CHATHAM COUNTY PURCHASING DEPARTMENT
ADDENDUM NO. 3 TO ITB # 17-0074-4

FOR: MEMORIAL STADIUM

ADDENDUM NO. 3

CHANGES TO PROJECT DRAWINGS:

Drawing No.: **C-10**

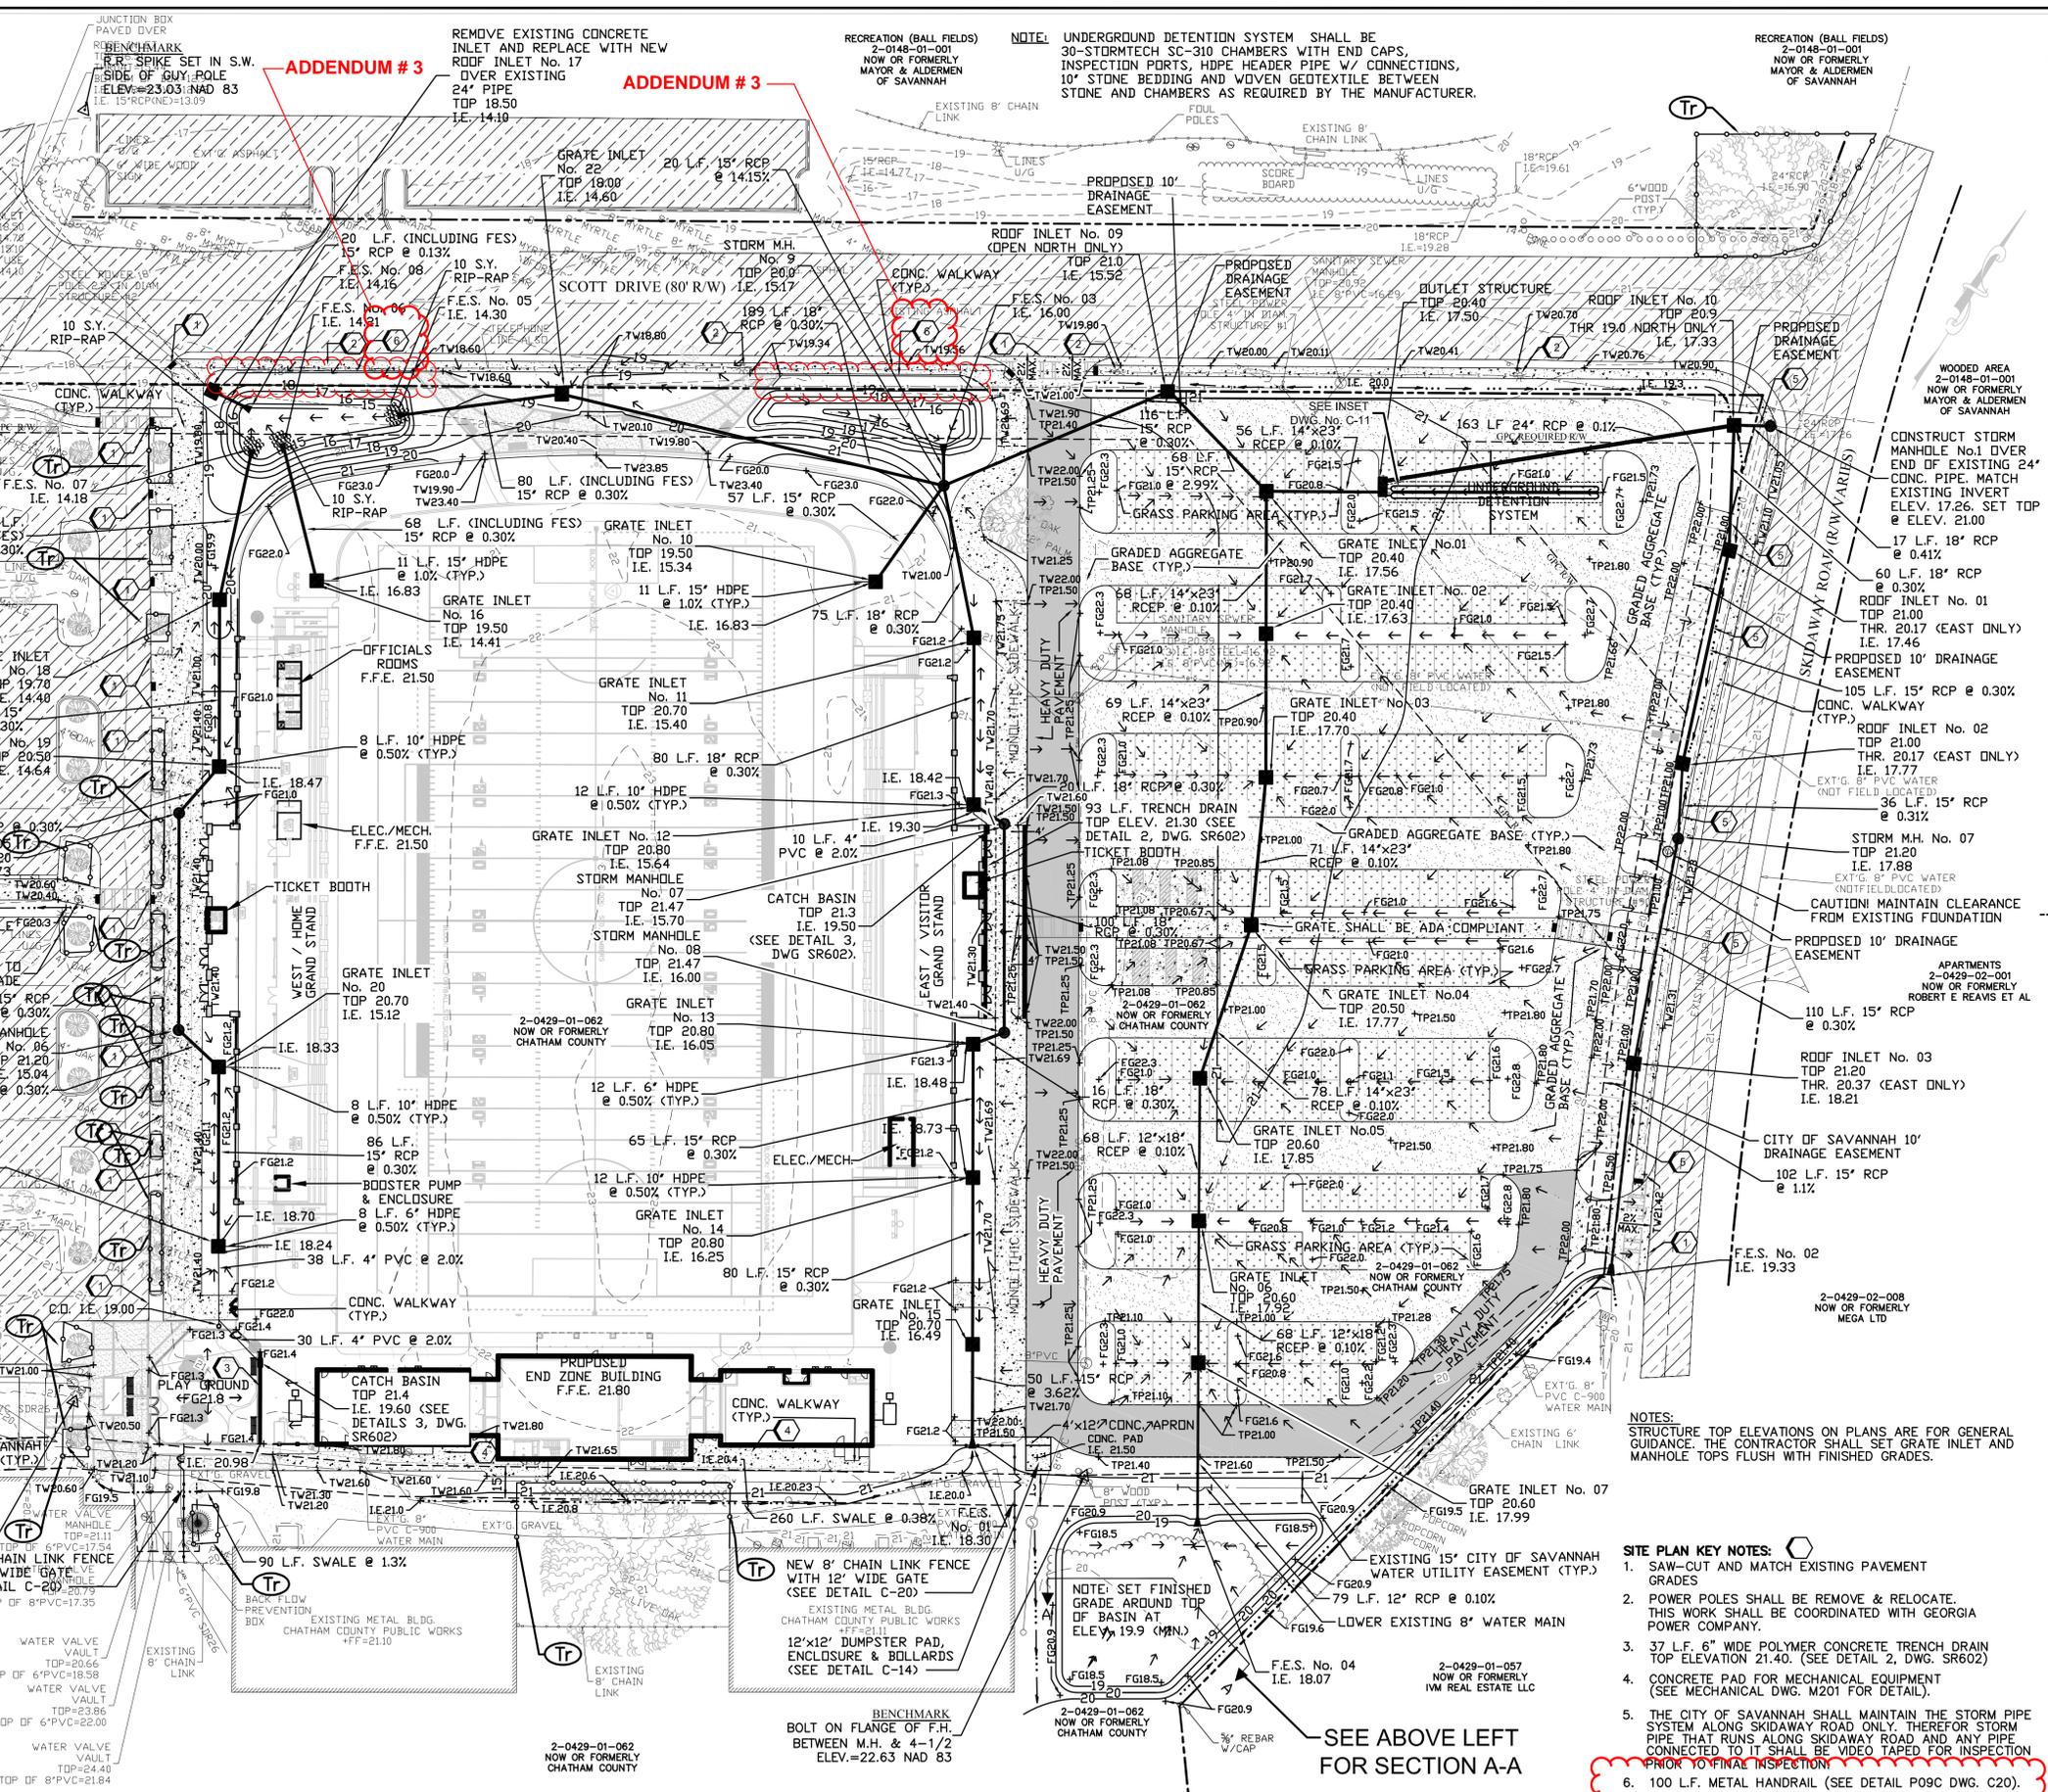
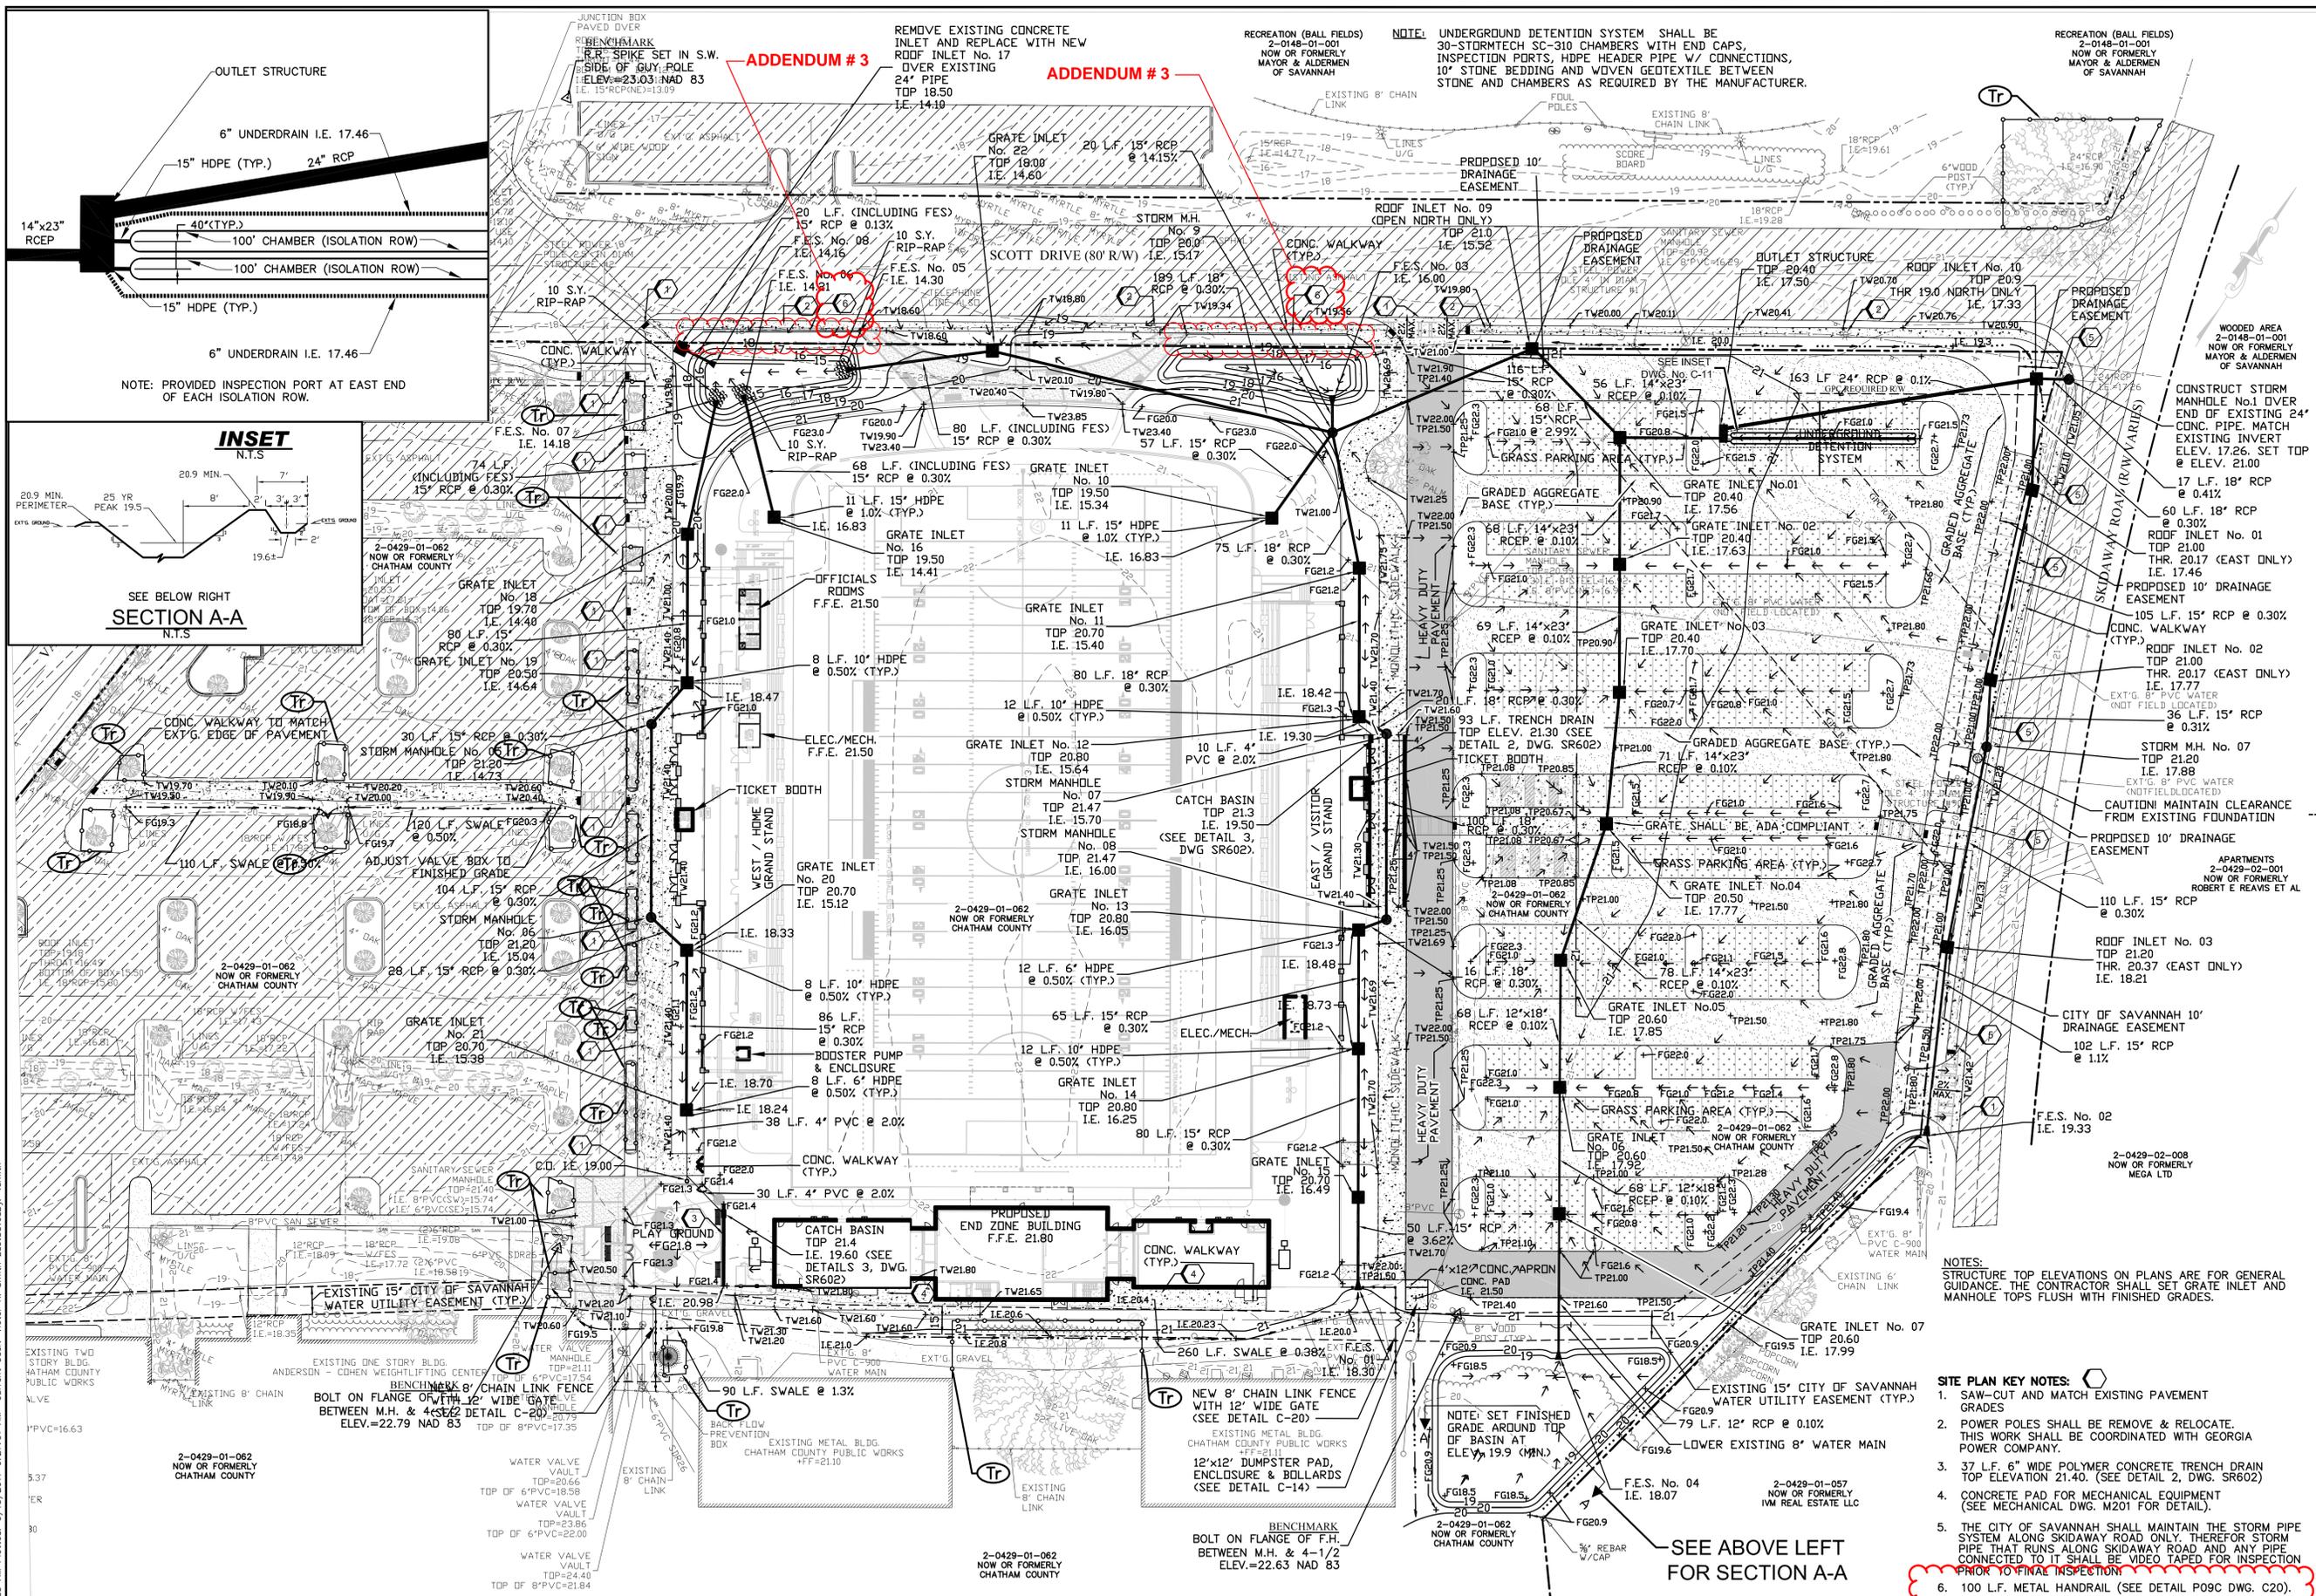
2. Drawing C-10: Revise drawing to include two 100-foot sections of handrail along sidewalk along Scott Drive.
3. Drawing C-11: Revise drawing to include two 100-foot sections of handrail along sidewalk along Scott Drive.
4. Drawing C-20: Revise drawing to include handrail detail.

SR101

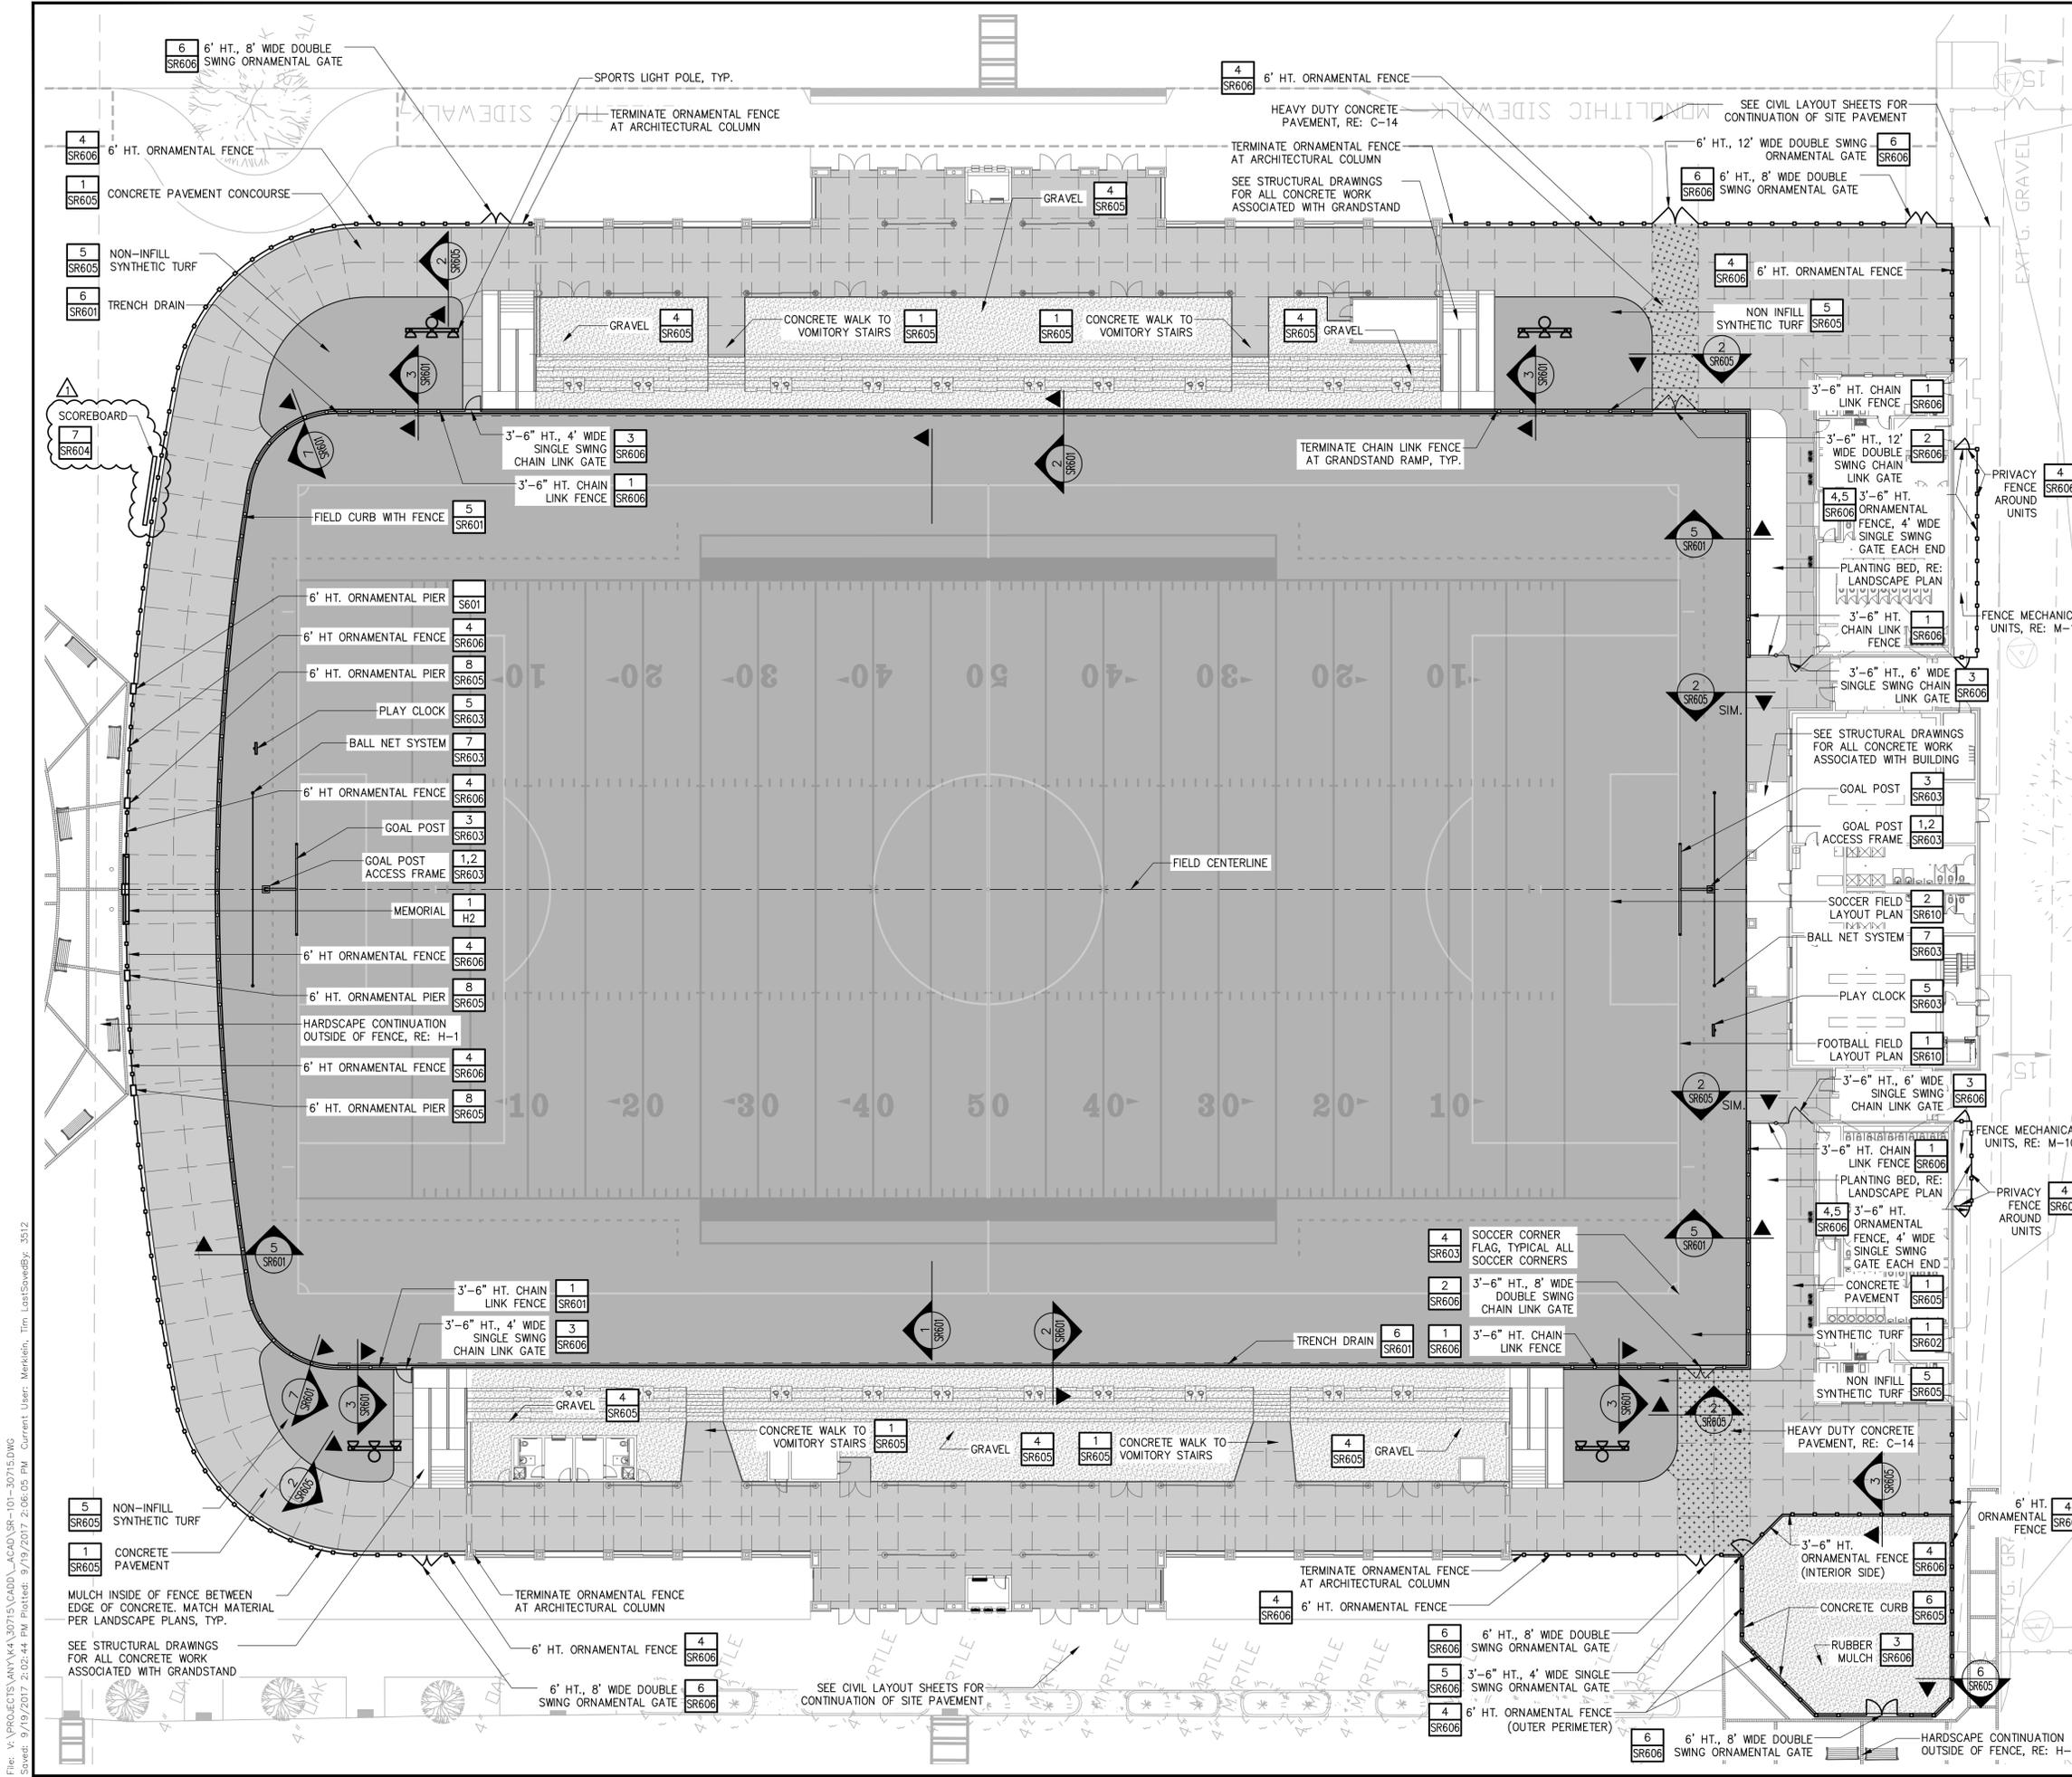
18. Question: The football scoreboard, called for in spec section 116843, is not shown on the Field Layout Plan, SR101; however, note 17 on sheet CE-002, which calls out the power requirements for the scoreboard is shown in the NE corner of the project. Please confirm that is the location of the scoreboard and provide a similar detail to detail 5, SR603, which shows the components and foundation for the play clocks.
Answer: Revised Drawings SR-101, SR-102, SR-111, & SR-604 address these scoreboard questions.
